Addendum Synthesis report possible impacts on water quality by future Alcolea dam

This document is an addendum to “*Synthesis report on the possible impacts on water quality by the future Alcolea dam*” produced by Deltares (reference: 11206708-002-ZWS-0002). The report, produced for the Junta de Andalucía, received after being made public external comments from two organizations. In this addendum we clarify and make adjustments as a response to these comments, when necessary, to certain calculations and conclusions that were made in the above-mentioned report.

Figura 5.- pH típicos a los que precipitan algunos iones metálicos.

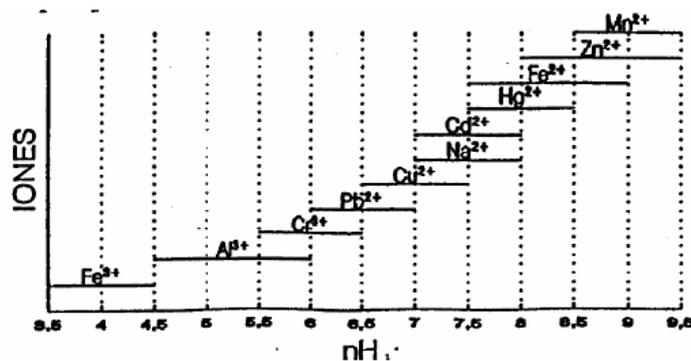
On page 27 of the report we wrote "A pH of 4.29 would allow all the iron compounds to precipitate and a large part of the Aluminum, Copper, Zinc, Manganese and other compounds to precipitate, greatly favoring the increase in water quality". This is not correct. For Iron it is still correct, but the other metals start to precipitate at higher pH levels as can be seen in the figure below (from the document "A21 Calidad de las Aguas.pdf").

Therefore, at a pH of 4.29 only precipitation of Iron (Fe^{3+}) may occur but other metals may remain in solution and therefore not contribute to an improved water quality.
